4. Driver Avenue steps – risk, disability access, integration with Moore Park

Saving Moore Park Inc. 17 July 2019

61 Moore Park Steps

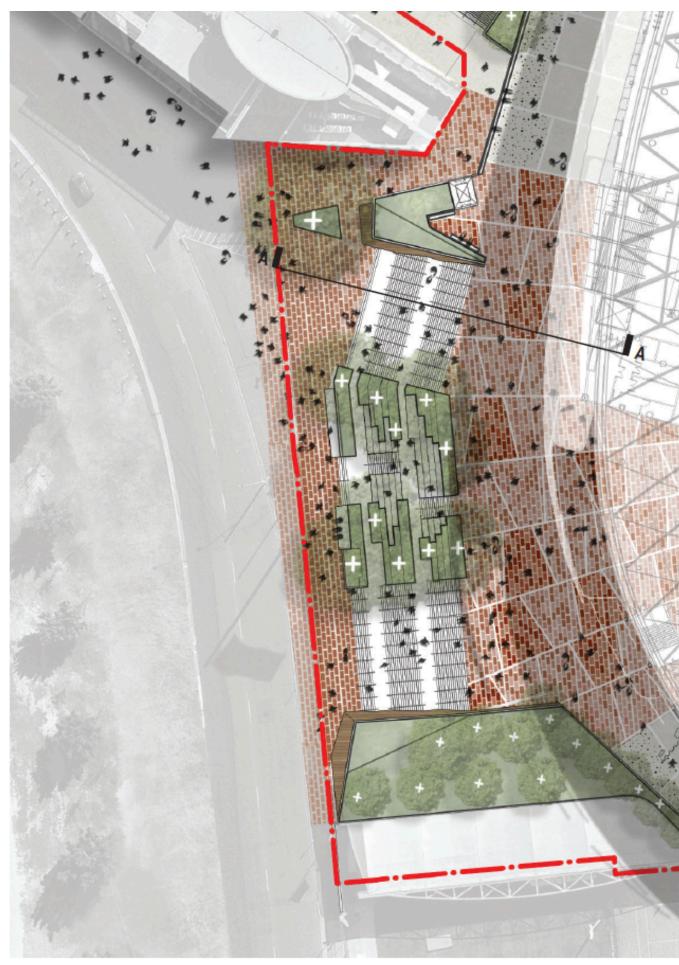
There appears to be no details as to the width of the steps. However, Diagram 61 in Appendix C1, Landscape & Public Domain Pt 1 (attached) shows that the steps are narrower at the bottom than at the top.

- In the unlikely event of a terrorist threat one can imagine the potential tragedy with people rushing to get away down the steps.
- The steps appear to converge slightly towards the bottom, so people will be channeled into a narrower exit point from the steps

- Sharp concrete terrace edges and central railings are also potential pressure points, with people being pushed against them

<u>Recommendation 1</u>: INSW should be asked to make information publicly available on the dimensions of the Driver Avenue steps – how many flights are proposed, the height of each, their width and whether they are as wide at the bottom as at the top.
